CAIRNGORMS NATIONAL PARK AUTHORITY

Title: REPORT ON CALLED-IN PLANNING APPLICATION

DEVELOPMENT PROPOSED: DESIGN REVISION TO PROPOSED BUILDING GRANTED PLANNING PERMISSION UNDER BS/02/119 ON LAND BETWEEN THE A889 AND RIVER TRUIM, NEAR DALWHINNIE JUNCTION, A9, DALWHINNIE (FULL PLANNING PERMISSION)

REFERENCE: 05/501/CP

Fig. 5 : Eastern elevation

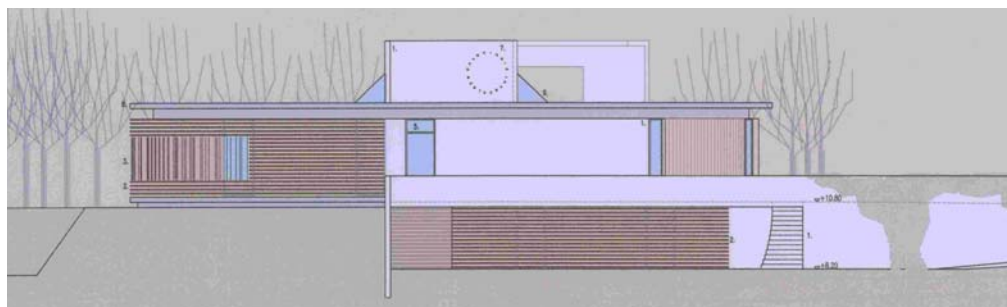
4. The current development proposal follows a very similar design approach to that previously employed, with a contemporary cylindrical structure proposed in the southern area of the site. The internal floor area of the overall building is 490 sq.m., with the ground floor occupying 315 sq.m., while the basement area has a total floor area of 175 sq.m.. Preparation and storage areas and plant areas, together with staff restrooms and public toilet facilities are proposed in the basement. At ground floor level, the internal floor space arrangement is divided between a retail element (43.30 sq.m.), tourist information facility (48.30sq.m.), service areas (89.70 sq.m.), circulation space (36.20sq.m.) and café / restaurant area (97.80sq.m.). In addition within the 'drum' structure is an open air play space and terraced area, with the provision of additional restaurant seating indicated in the latter area. The external finishes proposed consist of a combination of render finish on walls, together with extensive use of horizontal and vertical timber louvers and with all doors and windows having a colour coated aluminium frame. The building is proposed to have a flat roof of curved metal. Glazed areas are proposed on the southern elevation of the café / restaurant element of the structure. However, the glazed areas are to be largely concealed through the use of the timber louvers surrounding the open air terrace areas. The terrace and play area is created in an unroofed space between the render finished and glazed southern and part of the western walls of the internal floor space, with the terrace and play area subsequently being enveloped by an exterior circular layer. The exterior layer, consisting mainly of the timber louver finish effectively encases the main body of the structure, and to a certain extent camouflages the significant areas of rendered walls.

5. The Design Statement accompanying the application states that the “proposed building seeks to integrate with the wider landscape by means of its curved form, timber screens, and extended retaining walls. White walls are the norm for traditional buildings in the Scottish landscape. Retaining walls will be planted such that the surfaces merge with the landscaping.”

Fig. 8 : proposed ground floor layout

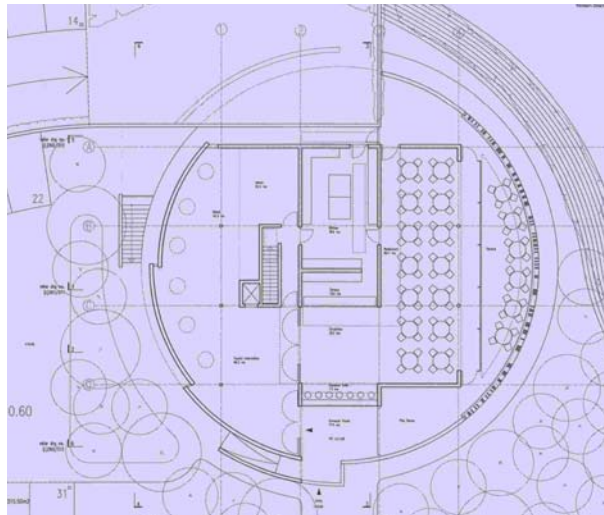
9. A ground floor layout plan shows an indicative seating layout of fourteen circular tables, each seating four (total = 56), as well as seven individual

seats accommodated in a small espresso café area. In addition, further restaurant seating in the form of six tables, each seating four (total = 24), is indicated in part of the sheltered open air terrace area, thereby resulting in an indicative seating capacity of 87 in the café / restaurant area. The previously refused proposal included a significantly larger internal restaurant floor area, as well as greater seating capacity in a larger terrace area. An indicative total seating capacity of 167 was shown in that instance. The reduced floor area of the café / restaurant element in the current proposal has resulted in a redistribution of floor space providing an increase of approximately 18 sq.m. in the retail unit, and a significant increase in the floor space of the proposed tourist information facility, increasing from an area of 25 sq.m. identified in the previously refused proposal to 48.3 sq.m. in the current proposal. External solid walls, devoid of any glazing are proposed in this area in an effort to further increase the exhibition space available for tourist information.

Fig. 14 : existing view from lay-by on A9 south of junction with A889

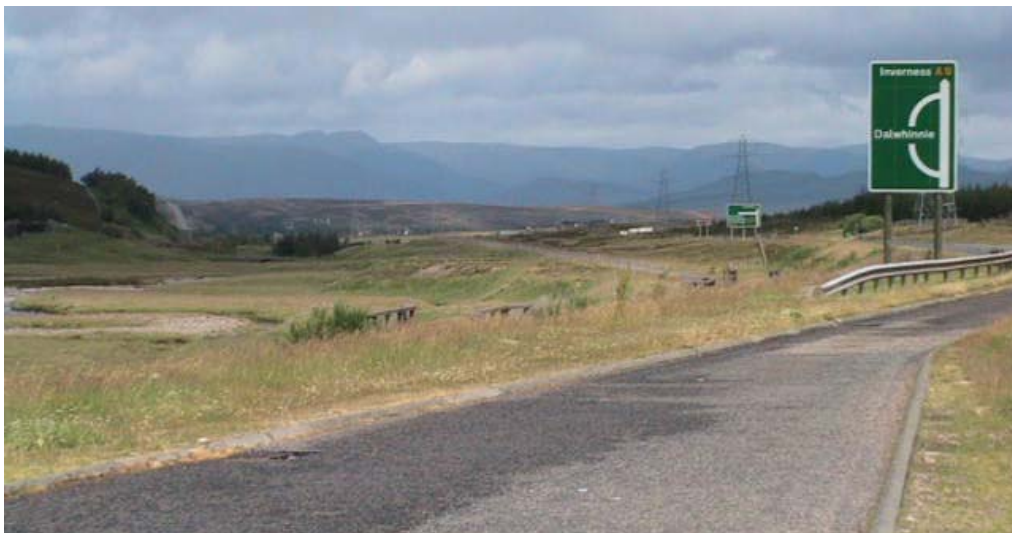
49. The currently proposed design is undeniably of higher quality than the structure previously permitted on the site. However, I remain particularly conscious of the relatively stark nature of the site, at present devoid of any significant levels of natural vegetation or screen planting, and readily visible from the southern and northern approaches of the A9 trunk road as well as from the adjacent railway line, and also from a number of hills in the surrounding area, many of which are frequently used by hillwalkers and others engaged in sporting activities. Any structure of the scale proposed will inevitably have a significant degree of visibility, although the current proposal will not perhaps have any greater a degree of visibility than the structure already permitted. It is imperative that an appropriate landscaping scheme is undertaken at the site in order to achieve maximum assimilation of the structure into the rugged and open landscape in which it is proposed and the applicant / agent has expressed their intentions to conform to this.
